Subject: Dendrobium Mine Area 5 Extension Project

WaterNSW appreciates the opportunity to comment on the Environmental Impact Statement (EIS) for the Dendrobium Mine Area 5 Extension Project (the Project). The Project has been declared as State Significant Infrastructure (SSI) under the *Environmental Planning and Assessment Act 1979* and will be determined by the Minister for Planning and Public Spaces.

Attachment 1 – WaterNSW Detailed Comments

Figure 1. Iron staining in Wongawilli Creek and reported results as presented in assessment of exceedance against the performance measure (HGEO, 2021)

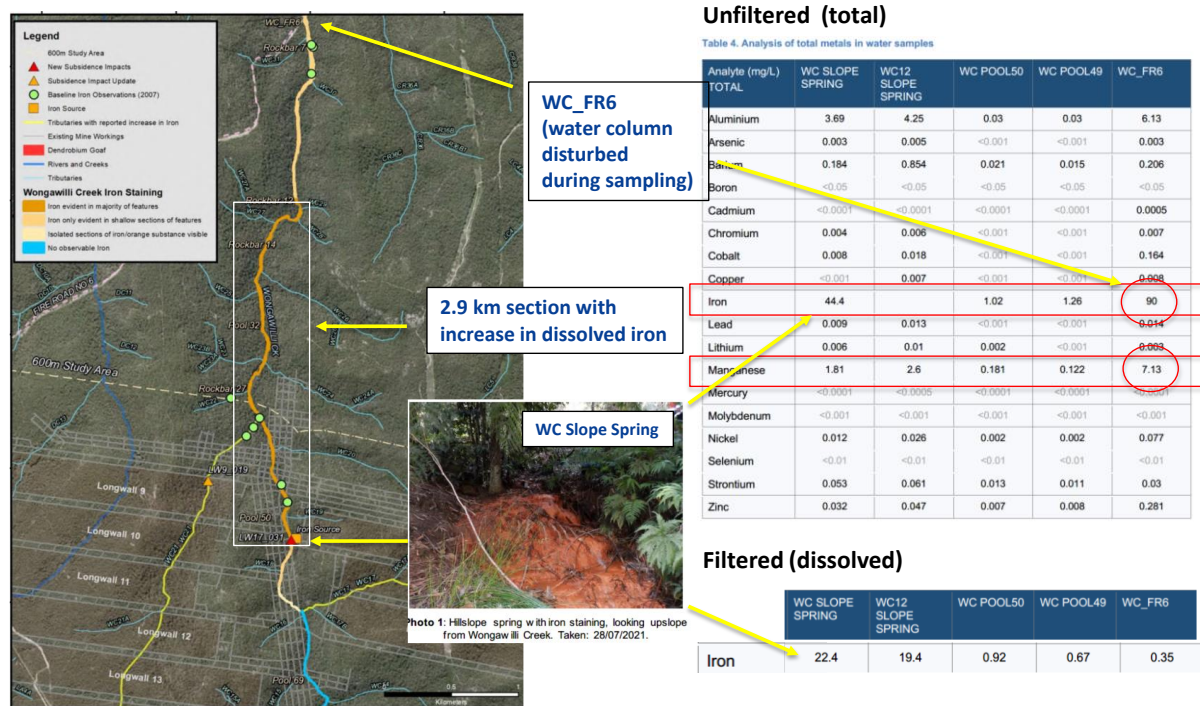
- Surface water assessment for End of Panel Longwall 17 has reported water quality impacts over past month. Groundwater recovery caused transient or persistent increases in EC, changes in pH or dissolved metals concentrations and increasing extent of iron staining in watercourses (WC, WC21, LA5, LA5, SC10C) that flow across longwalls in Areas 3A and 3B.

- Groundwater seepages observed in Wongawilli Ck and WC12 tributary appear to have dissolved concentration of iron up to 22.4 mg/L and manganese up to 1.77 mg/L. Ecoengineers (2012) reported the ferruginous springs over Dendrobium mine area may exhibit elevated concentrations of up to 40 mg/L of iron and up to 2 mg/L of manganese. Similar iron concentrations have been also observed in shallow groundwater at other undermined areas by Metropolitan mine (20-35 mg/L). In the context of other water quality parameters, dissolved iron in groundwater from subsided areas may reach concentrations levels comparable or exceeding major ions (sodium, calcium).

- Observed water quality impacts become more widespread as proportions of undermined areas are increasing. Iron staining has been noted or reported in catchments undermined by other mines (Elouera, Metropolitan).

Figure 2. Flow observations in pools in WC15 over Area 3B (HGEO, 2022).

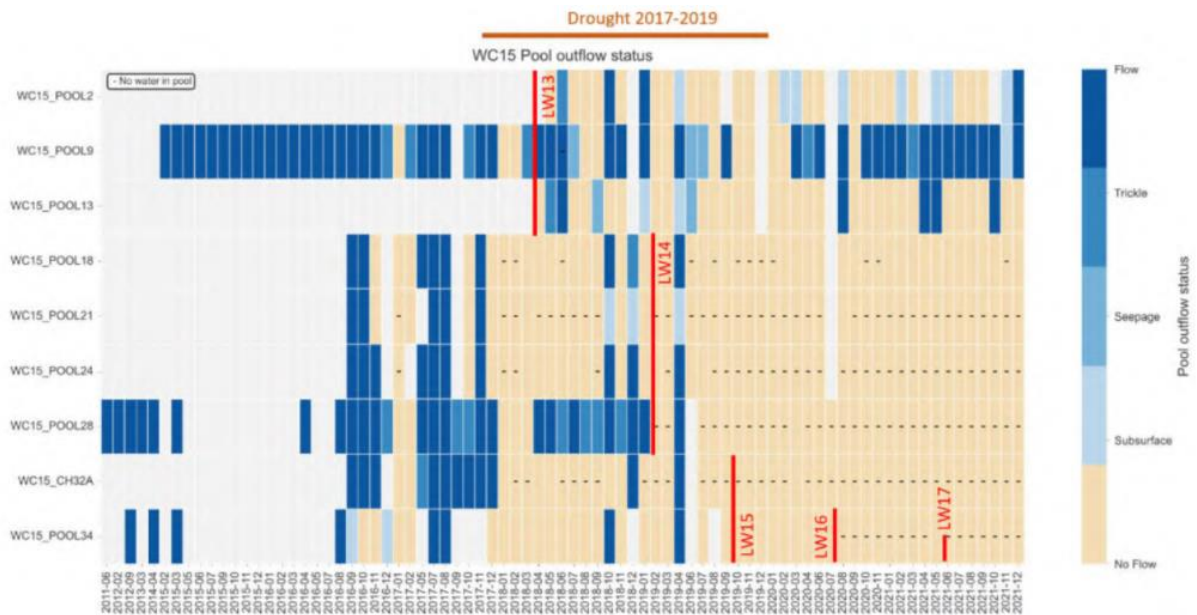
- Figure 2 shows interpretations of visual observations of **loss of water holding capacity** of pools in WC15 watercourse undermined by several longwalls. These pools were supposed to overflow during higher-than-average rainfall in 2021 but remained empty during reporting period (HGEO, 2022).

Figure 3 Landscape impacts by feature and trigger level

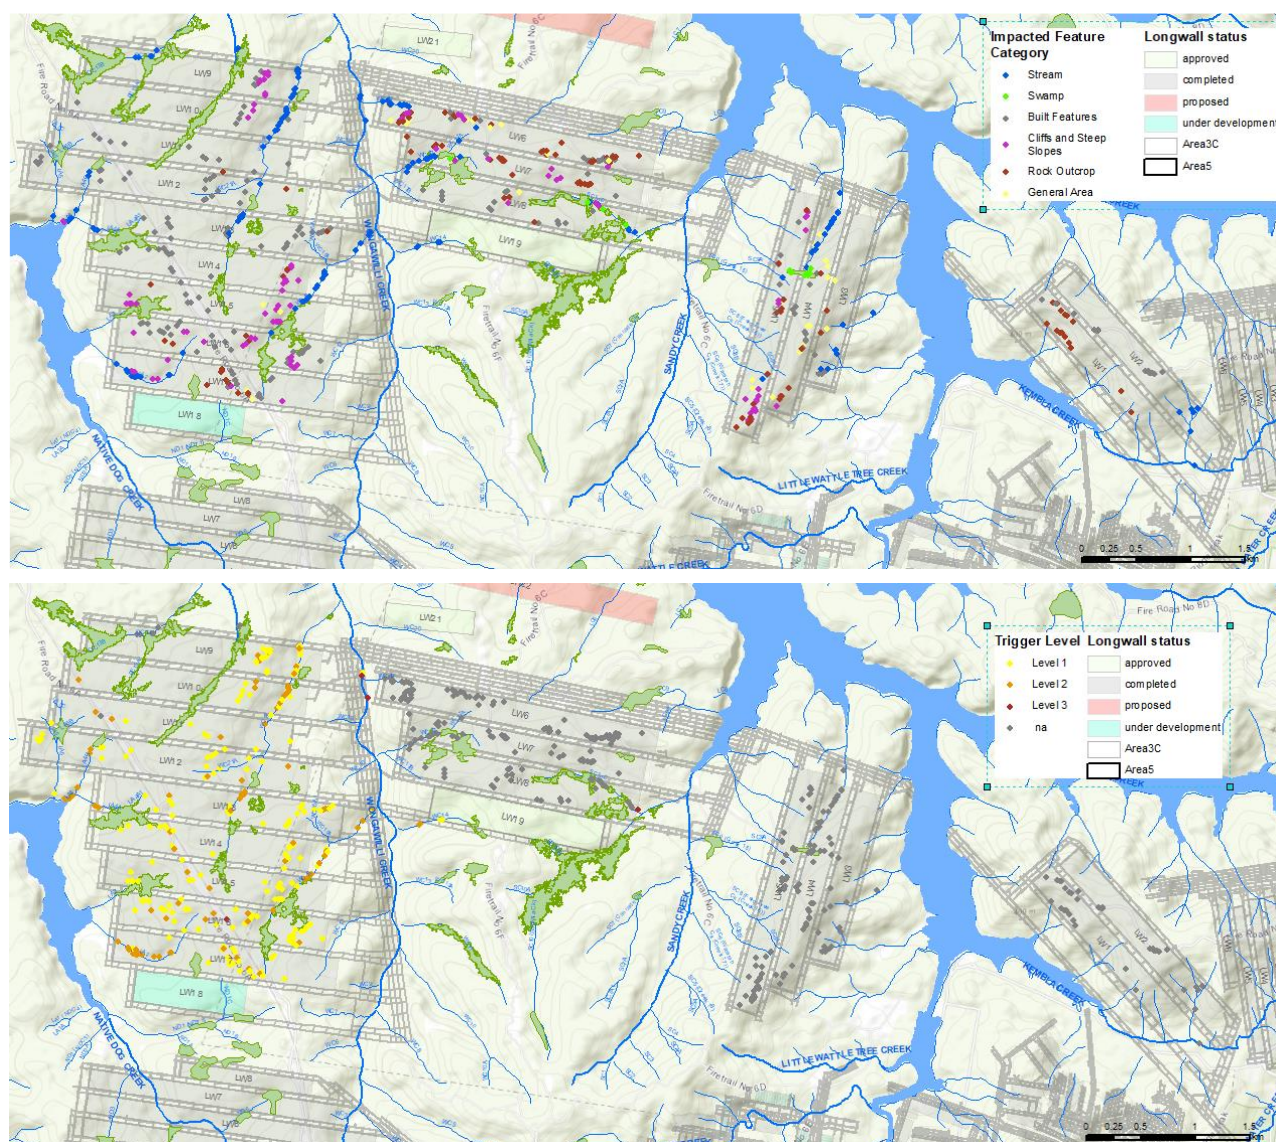
Mining at Dendrobium to date has resulted in widespread surface impacts (Figure 3) on the area overlying the mining footprint that are having a very significant impact on water quality and the ecological integrity of the Metropolitan Special Areas.

WaterNSW estimates that over 670 impacts have been reported to date by IMC in impact assessment reports and End of Panel reports and is based on specific targeted monitoring locations. As such it is likely that the extent of these impacts in the areas mined will be much larger and hidden by vegetation cover. The reported impacts include impacts to streams, swamps, cliffs and steep slopes, rock outcrops, built features and general catchment area. These impacts have been classified into TARP trigger levels 1, 2 and 3 (in increasing order of severity).
